**EUGENE SCHOOL DISTRICT 4J
NEW WHEELCHAIR LIFT - 2016
TWIN OAKS ELEMENTARY**
Eugene, Oregon
gLAS Project No. 15028

ADDENDUM NUMBER TWO

February 26, 2016

UPPER FLOOR PLAN - PARTIAL		
	SCALE: 1/4" = 1'-0"		
	EUGENE SD4J - TWIN OAKS ELEM. NEW WHEELCHAIR LIFTS - 2015	15028	AI-R
		11/15/15

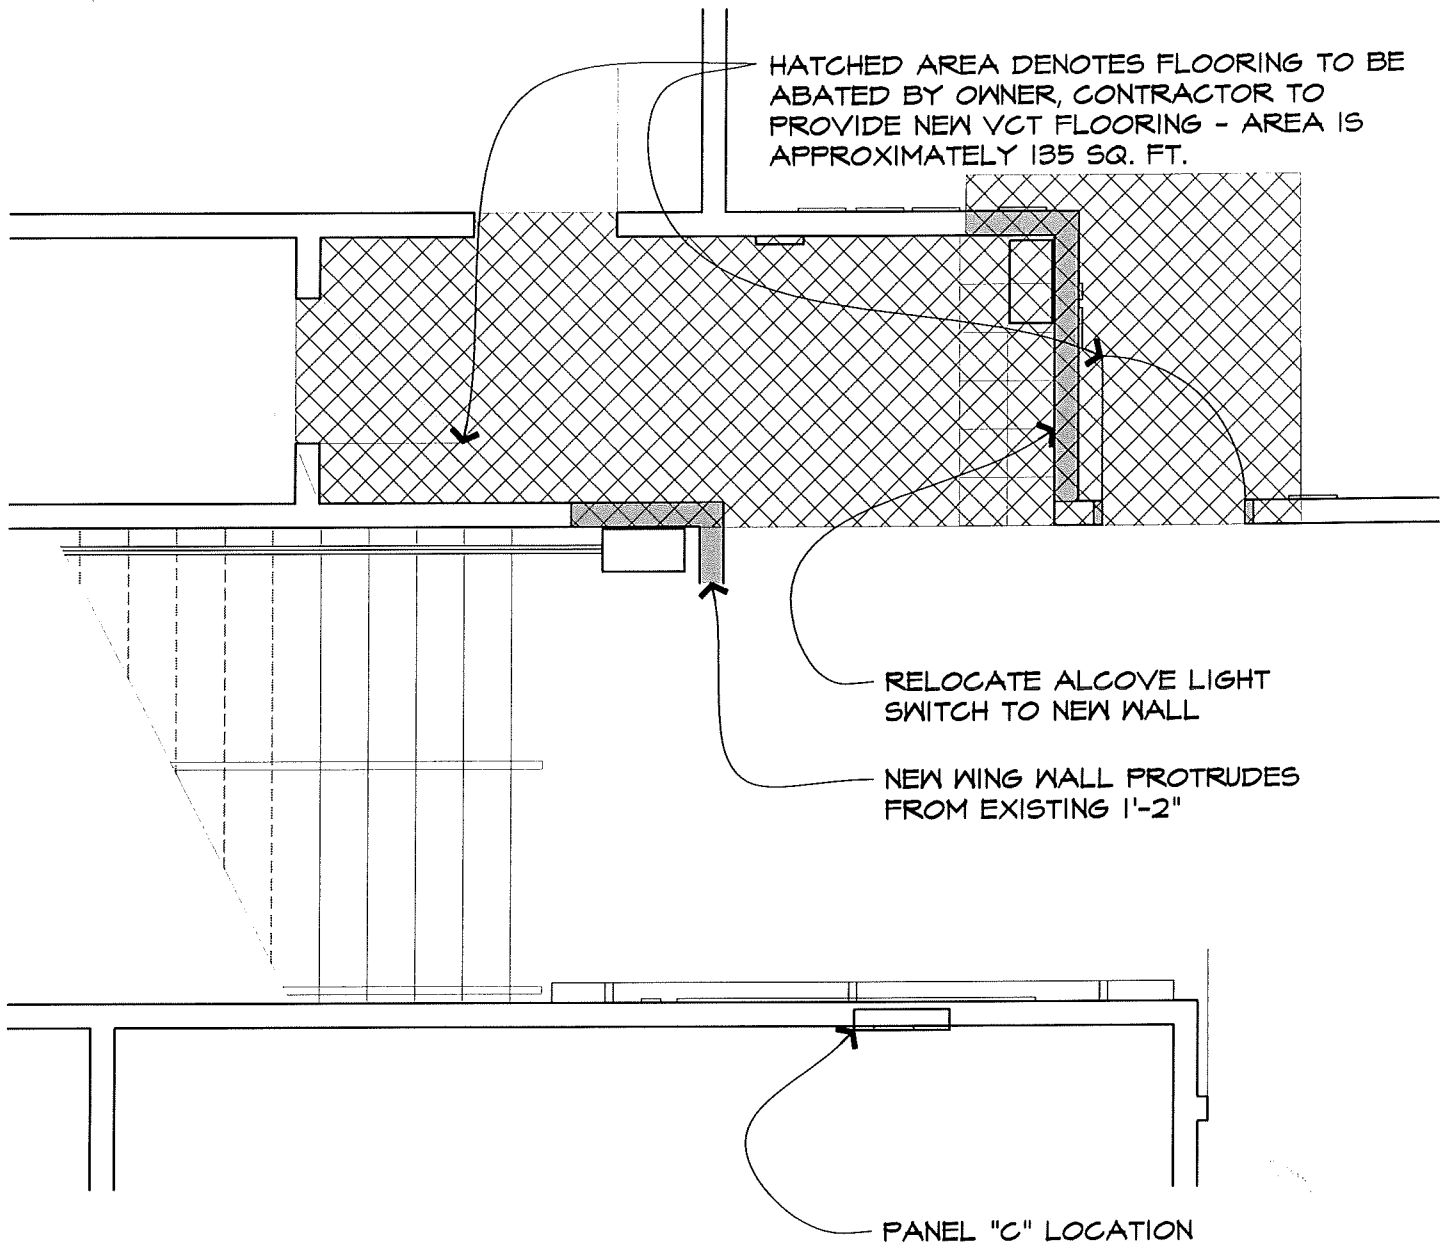
- 2) Section 01100, Summary of Work, Page 01100-2.
 - a) Clarification: The Owner will contract separately for abatement of asbestos containing floor and wall finish materials at the area of construction. Flooring will be abated at the area indicated on the attached sketch I/A-1R.

- c) Contractor shall provide new resilient vinyl tile flooring and resilient base at the abated area. Contractor shall provide wall finishes at the areas of new framing. See attached floor plan sketch for flooring areas.
